COUNCIL REPORT

Date:	January 7, 2021
From:	Erika Syvokas, Assistant Planner
Subject:	Proposed Heritage Alteration Permit for the Ferry Building
File:	1010-20-20-111

To consider proposed Heritage Alteration Permit No. 20-111 which would allow for alterations to the Ferry Building at 1414 Argyle Avenue, 101 14th Street, 1420 Argyle Avenue and 1430 Argyle Avenue (the Site).

PROPOSED BUILDING SECTION

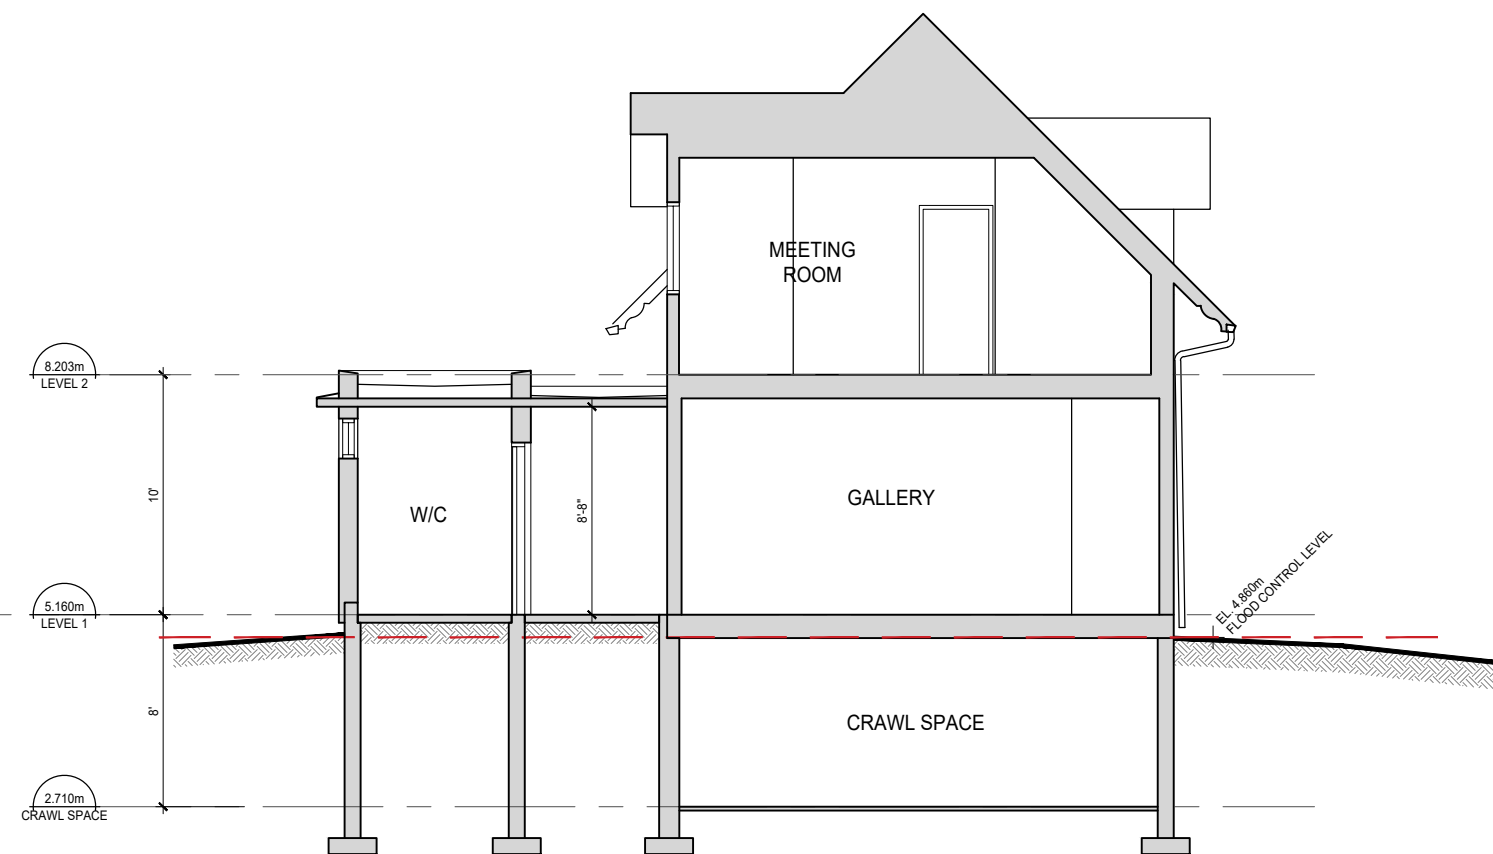
We refer to the email from Michael Sayachack of DA Architects + Planners dated 26th November 2020 and the Ferry Building plans attached to that email. For reference the drawings are appended to this letter as Attachment A. The drawings show modifications planned for the Ferry Building to accommodate the year 2100 Flood Construction Level (FCL) of +4.86 m CGVD2013.

The District has asked WSP to review the drawings and to provide advice on the flood control mitigation measures for the project.

The modifications proposed for the Ferry Building as detailed on the drawings in Attachment A involve siting the building on a mound with a floor level of +5.16 m. The datum used is not noted on the drawings and we assume the same datum (CGVD2013) applies, however this should be confirmed.

As the District is looking to address the general flood risk in the area as part of the Ambleside Park Plan, Item 3 above represents an acceptable approach.
